# Addendum 1

**City of Canton, Ohio**  
Purchasing Department  
218 Cleveland Ave. SW, 4<sup>th</sup> floor  
Canton, Ohio 44702

Sugar Creek Water Treatment Plant Lagoon Cleanout, Removal & Disposal of Sludge  
**Item/Project**

LAGOON GRADING PLAN

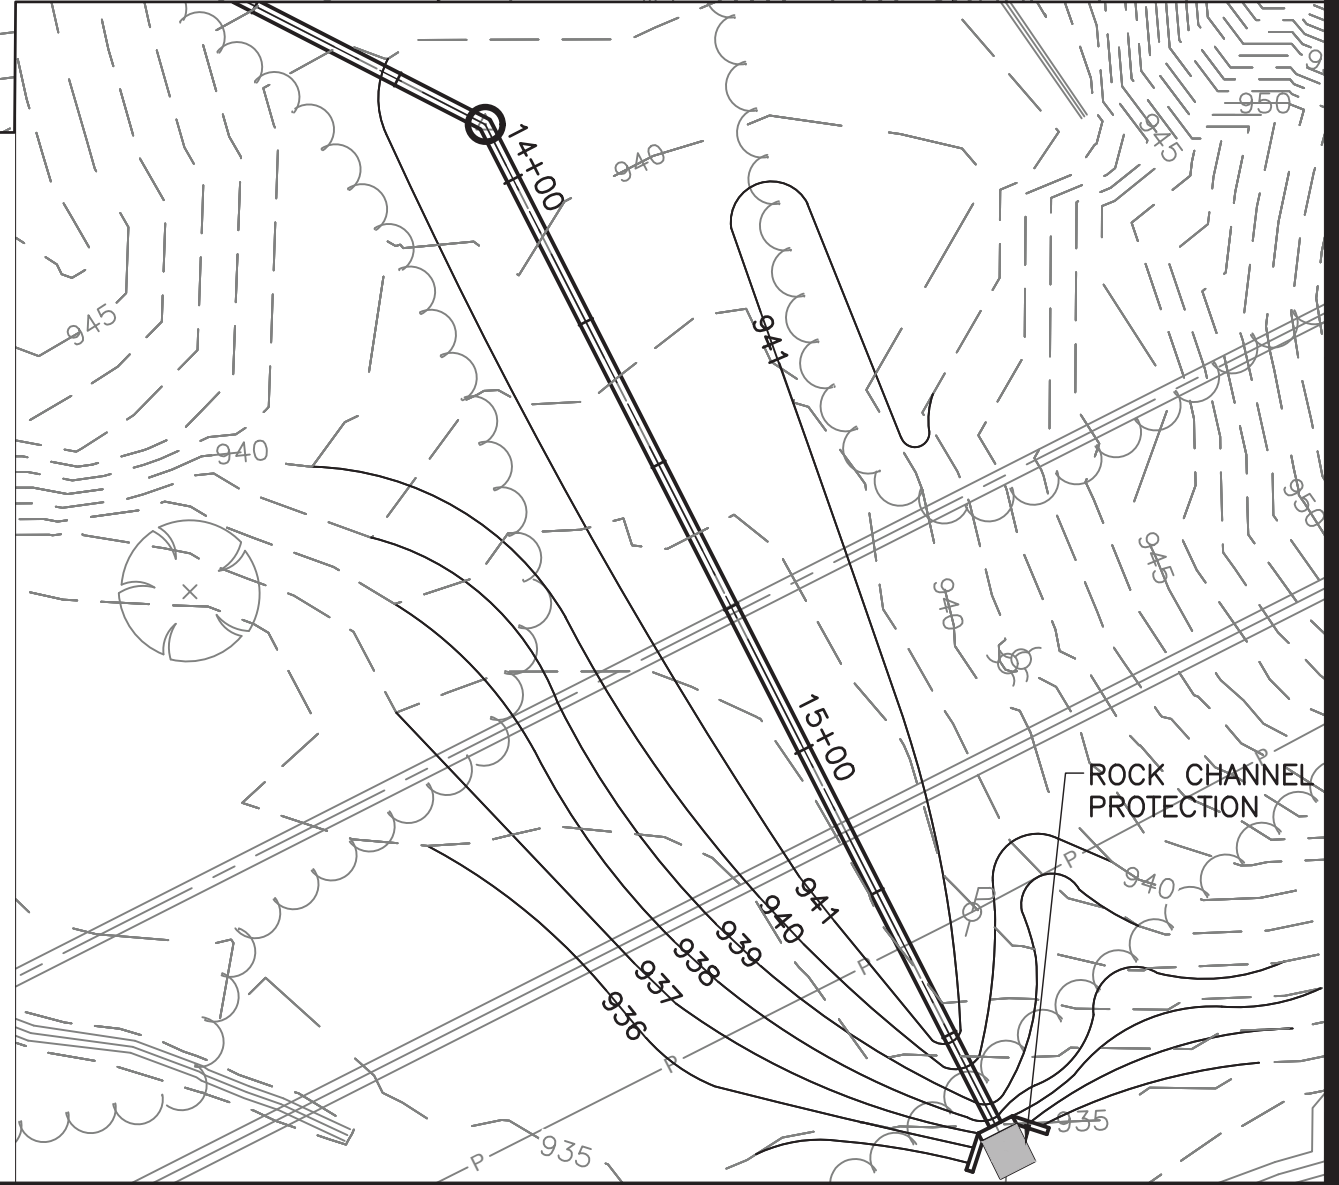
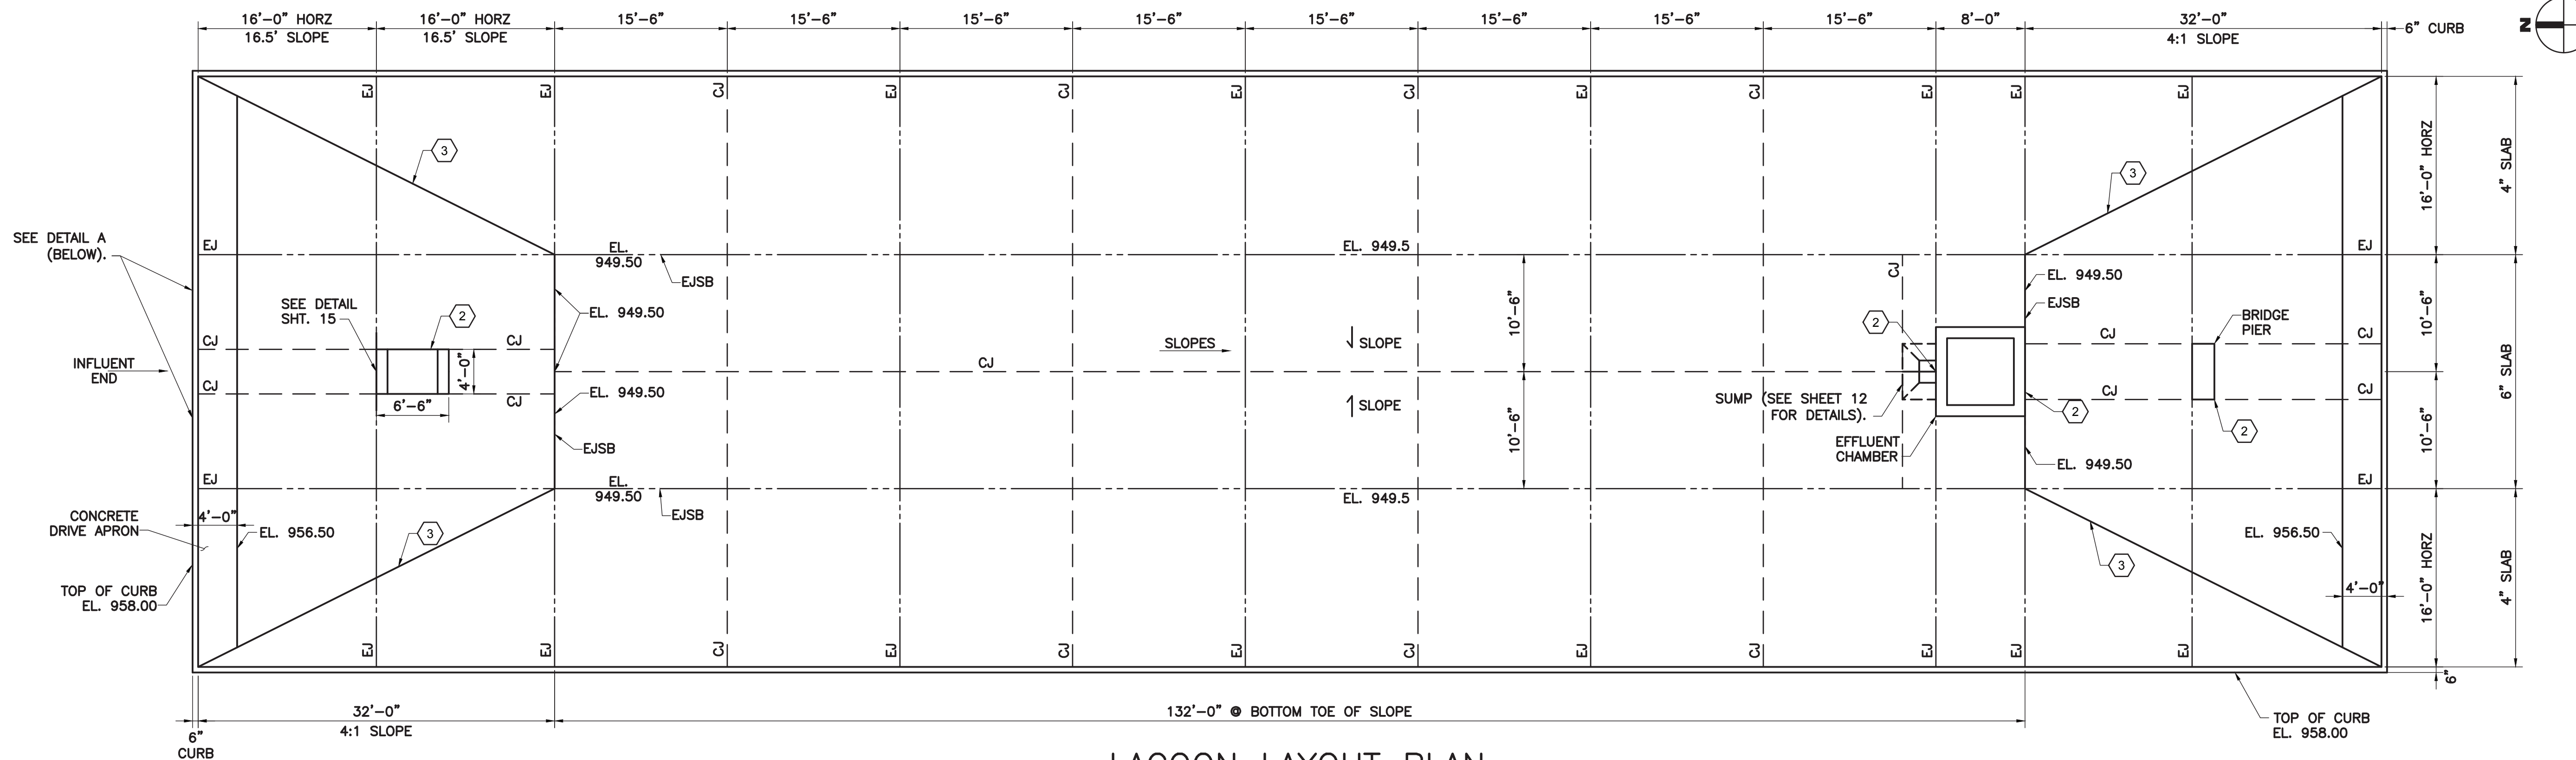
The specifications do not include any physical descriptions of the lagoon basins and the amount of sludge to be expected.

For details on the basins, please see the attached "Lagoon Plans and Sections.pdf". Since this is only the second year of cleaning these lagoons, the amount of sludge expected to be removed from each lagoon is undetermined at this point. It could range anywhere from 10" to 24". The weight of the sludge will be dependent on how well we can de-water it.

LAGOON PLAN & SECTION

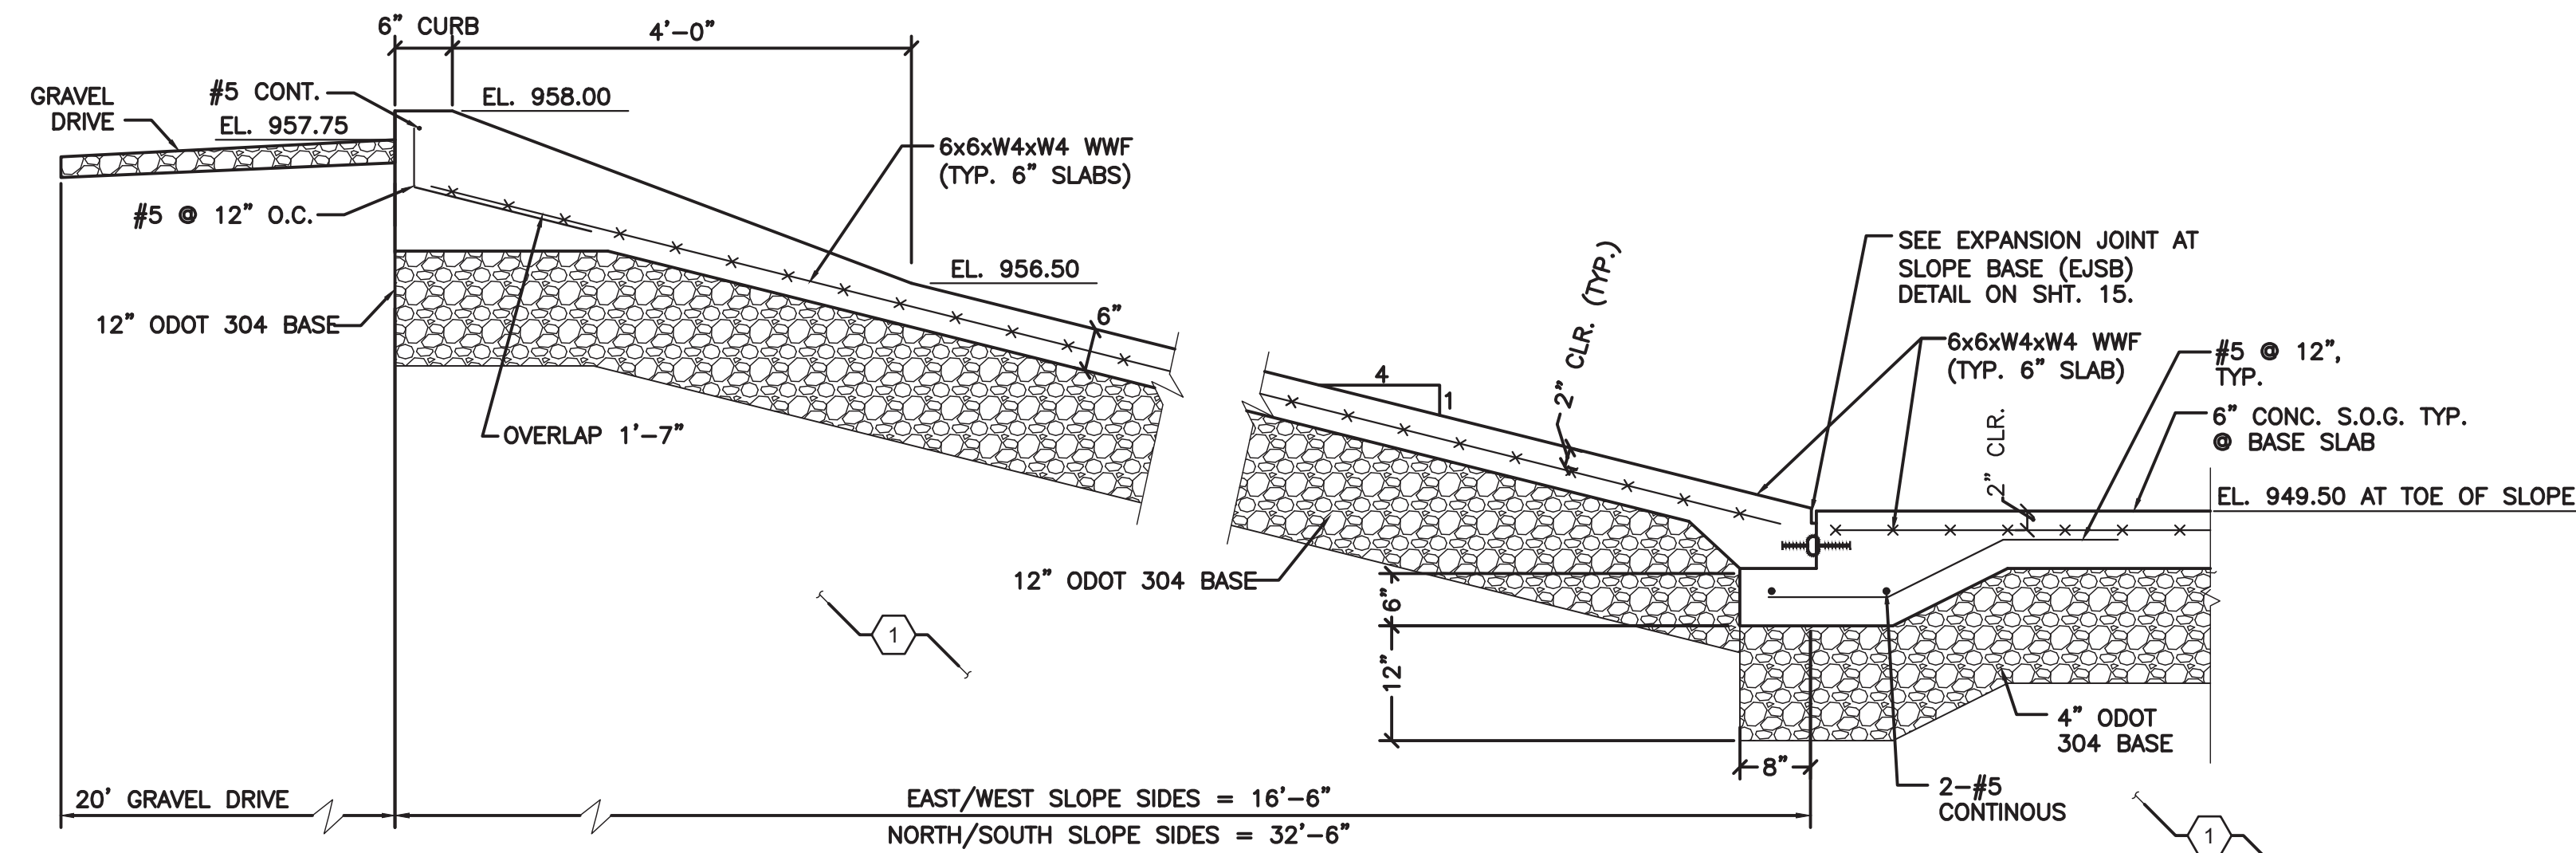
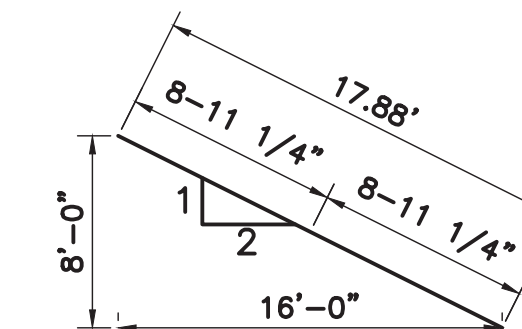
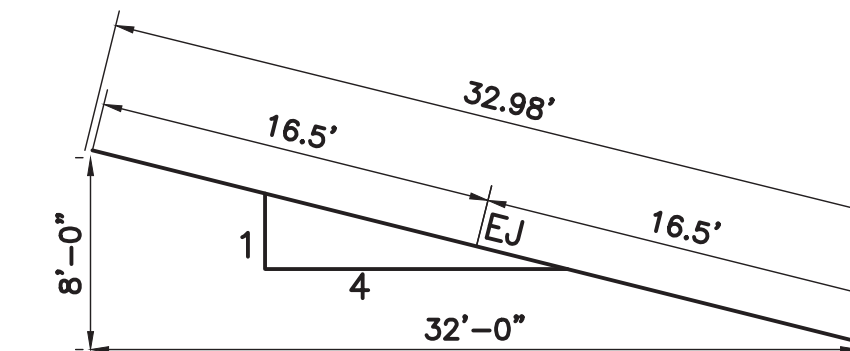
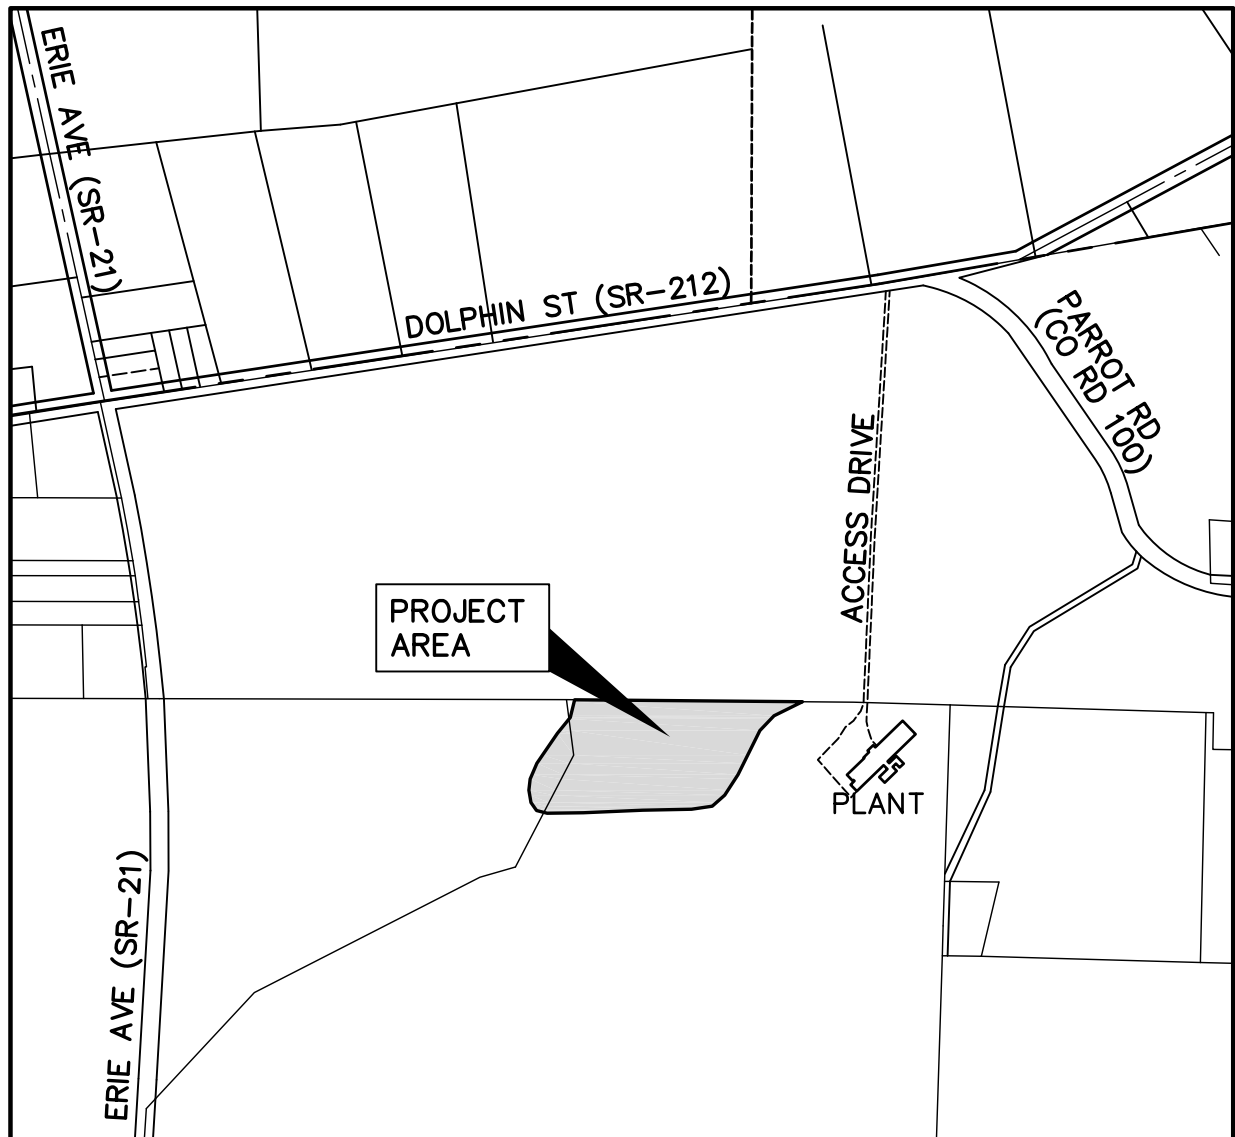
How are the lagoon basins constructed and lined, and how will the contractor protect the lagoon basin liner?

If you are open to all methods, can we fit a hydraulic dredge in the 3 ponds?

The lagoons are constructed out of concrete. See the attached Lagoons and Sections pdf attached. In past cleanings, a solid, plastic sleeve was fabricated and attached to the front of the backhoe's bucket.

Please see the attached "Lagoon Plans and Sections.pdf" for the size of the lagoons.
